MILITARY SPECIFICATION

DUCT AND SCUFF COVER, PNEUMATIC, FLEXIBLE

This amendment forms a part of Military Specification MIL-D-22706E(AS), dated 15 October 1985 and is approved for use by all Departments and Agencies of the Department of Defense.

FIGURE 2. Duct 30-foot, 60-foot length.

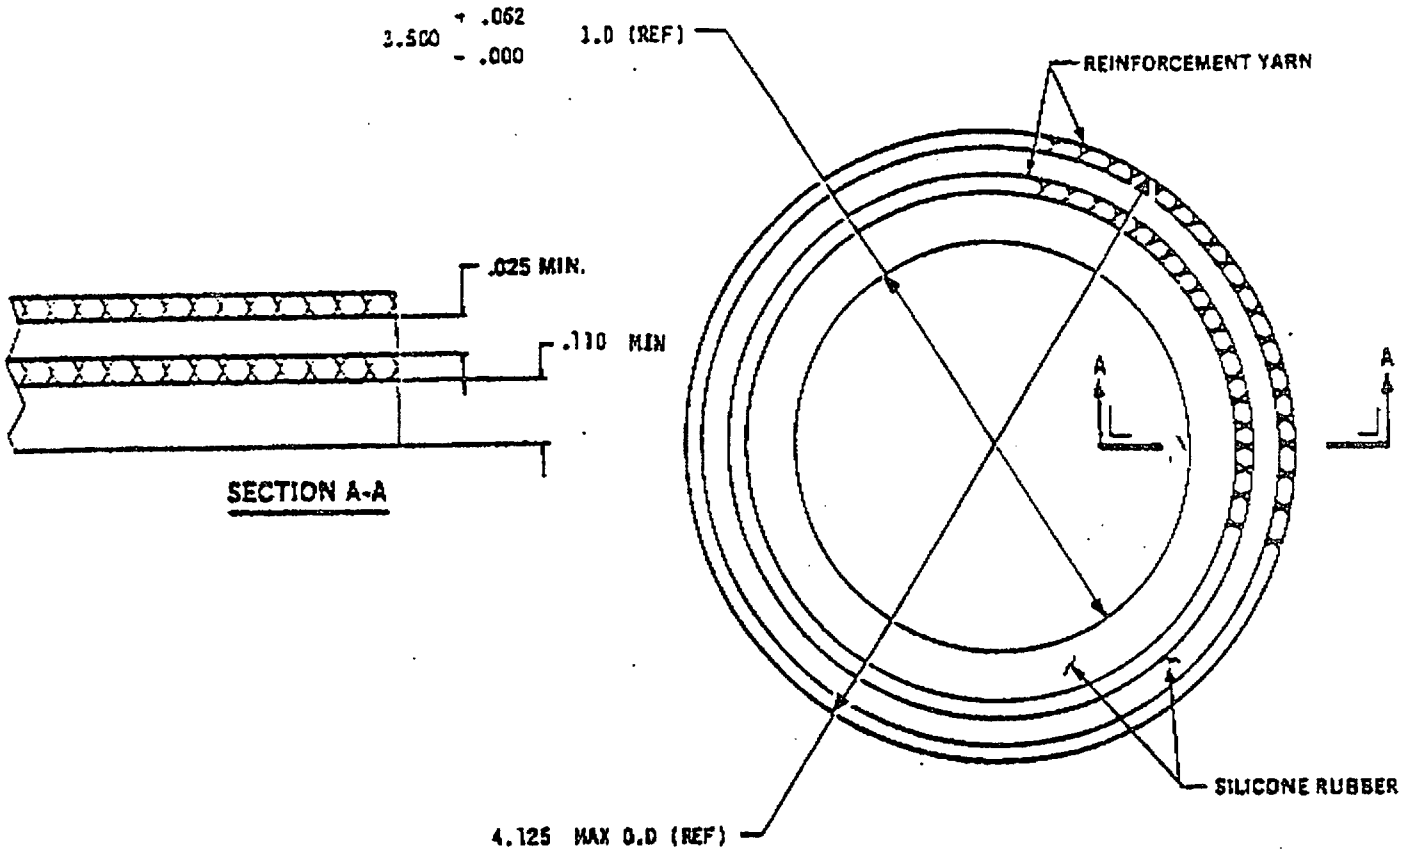
Delete and substitute Figure 2 as per attached drawing.

3.4 Design and construction. The assembly shall consist of a length specified by the procuring activity or contracting activity (see 1.2 and 6.2). An easily replaceable scuff cover (Figure 1) shall be used. The duct shall be manufactured using a two layer (minimum) construction (silicone covered by reinforcement material will constitute one layer). Reinforcement material is defined as yarn spiraled on the silicone at approximately 45° to the duct or one braid of yarn. The second layer of reinforcement material shall be placed at approximately 90° to the first reinforcement layer. The inner wall of silicone shall have minimum wall thicknesses of .025 and .110 of an inch respectively, followed by reinforcement material as shown in Figure 2. The duct shall be designed to be compatible with MS17833 and MS17835 (see Appendix).

3.4.1.1 Dimensions. The duct shall be of 30-foot or 60-foot length as specified. The duct shall have a uniform wall thickness with a tolerance of ± .032 inch exclusive of the scuff cover. The inside diameter of the duct shall be not less than 3.500 inches nor greater than 3.563 inches at standard day conditions. The outside diameter shall be as small as possible consistent with the requirements specified herein but shall be not greater than 4.125 inches. The duct construction shall be uniform throughout so that it will be possible to cut off a section of the duct at any location and reconnect to any of the standard beaded shank end fittings. No painting nor any other special treatment of the cut surface shall be required.
